## DRAINAGE INFORMATION SHEET

PRINCESS JEANNE SHOPPING

RE: DRAINAGE PLAN FOR CENTER PAD SITE #1  
(J-21/D19) REVISION DATED AUGUST 22, 1988

## GRADING & DRAINAGE PLAN PRINCESS JEANNE SHOPPING CENTER

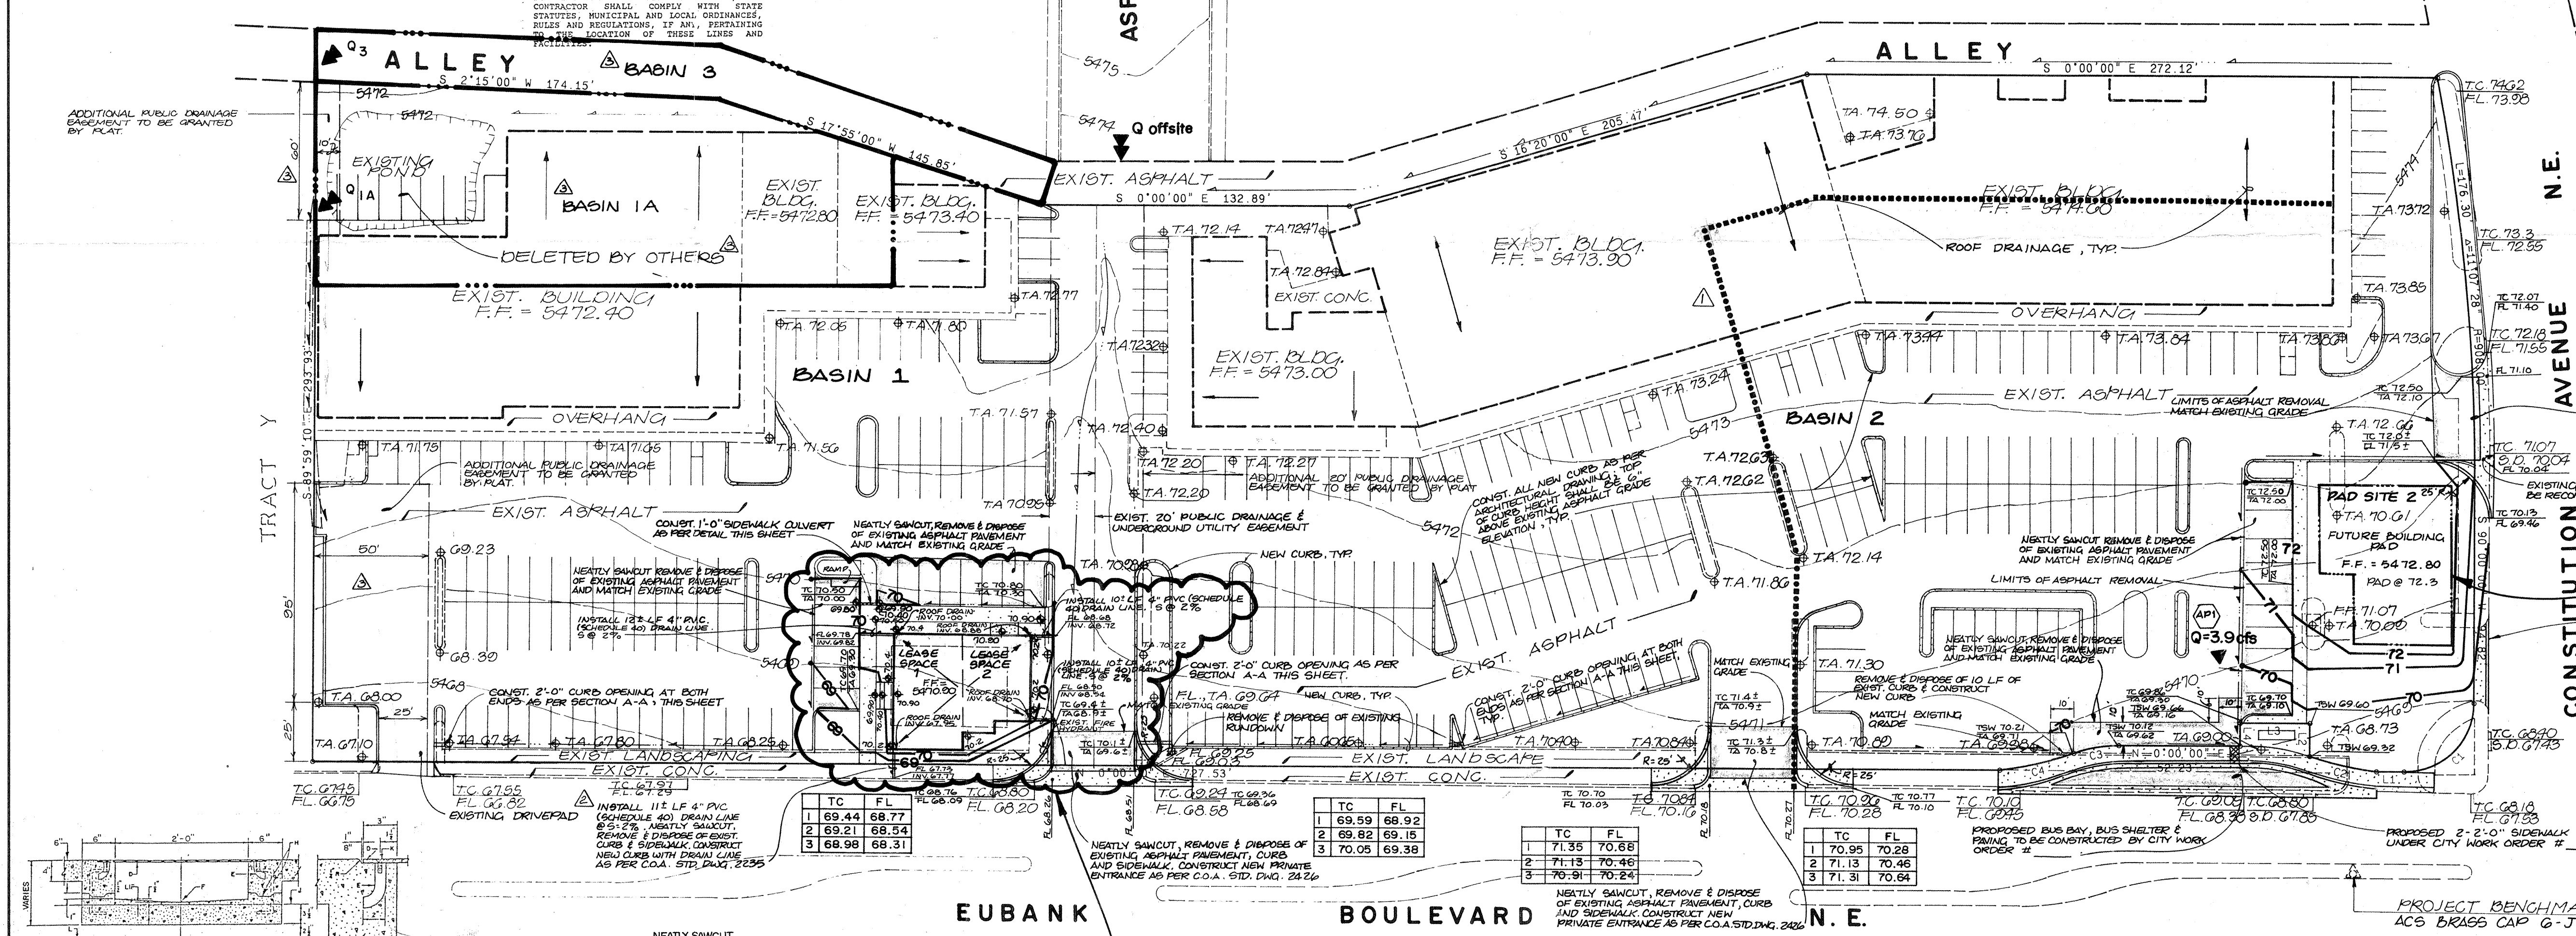
Prior to release of the Certificate of Occupancy, we will need a copy of the approved plat showing the grant of easement.

In order to install the 4" PVC pipe through the curb the contractor will need to remove the complete stone (saw cut is not allowed by spec). A separate permit is required for construction within City right-of-way. The contractor will need a copy of this approval letter when applying for the excavation permit.

Please attach a copy of this plan to the construction sets prior to sign-off by Hydrology.
